Project	<b>IEEE 802.16 Broadband Wireless Access Working Group</b> < <a href="http://ieee802.org/16">http://ieee802.org/16</a> >	
Title	<b>Residual Termination Block Processing with CTS</b>	
Date Submitted	<b>2005-07-14</b>	
Source(s)	Zhengfei Xiao, Yongmao Li, Phillip Barber, Jim Carlo, David Xiang, Duke Dang, Lucy Chen, John Lee	<a href="mailto:john_lee@huawei.com">mailto:john_lee@huawei.com</a>
	HUAWEI	
Re:	Call for contribution and comments.	
Abstract	Residual Termination Block Processing with CTS.	
Purpose	Adoption	
Notice	This document has been prepared to assist IEEE 802.16. It is offered as a basis for discussion and is not binding on the contributing individual(s) or organization(s). The material in this document is subject to change in form and content after further study. The contributor(s) reserve(s) the right to add, amend or withdraw material contained herein.	
Release	The contributor grants a free, irrevocable license to the IEEE to incorporate material contained in this contribution, and any modifications thereof, in the creation of an IEEE Standards publication; to copyright in the IEEE's name any IEEE Standards publication even though it may include portions of th

**Figure 137d—Residual termination block processing with CTS**

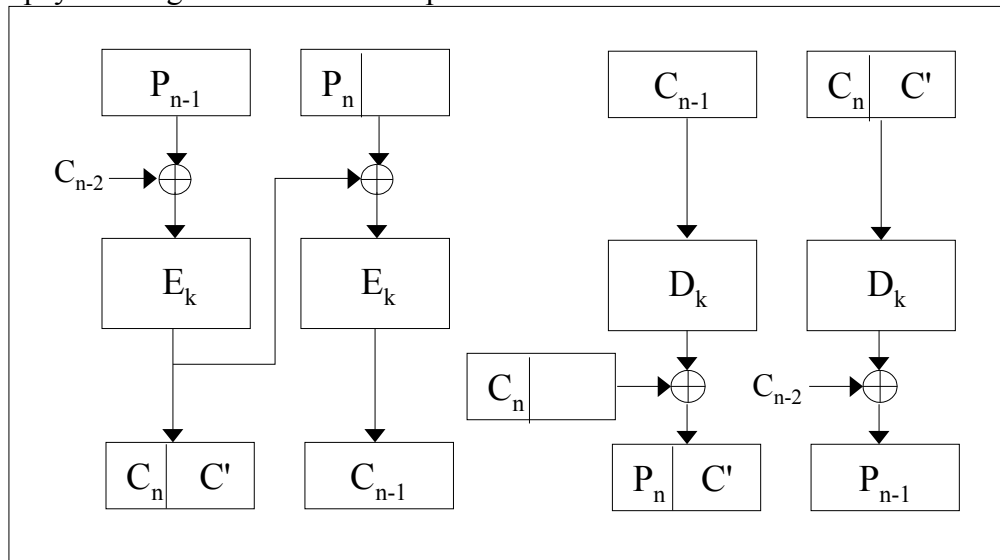
Residual termination block processing shall be used to encrypt the final block of plaintext when the final block is less than the cipher block size. Given a final block having  $n$  bits, where  $n$  is less than the cipher block size  $m$ , the next-to-last ciphertext block shall be divided into two parts. One of the two parts is  $n$  bits, the other part is  $m-n$  bits. The former will be sent to receiver as the final block ciphertext. Padding the final short block to obtain a complete plaintext block, then encrypt it with AES algorithm in CBC mode. The encryption and decryption procedure is depicted in Figure 137d.
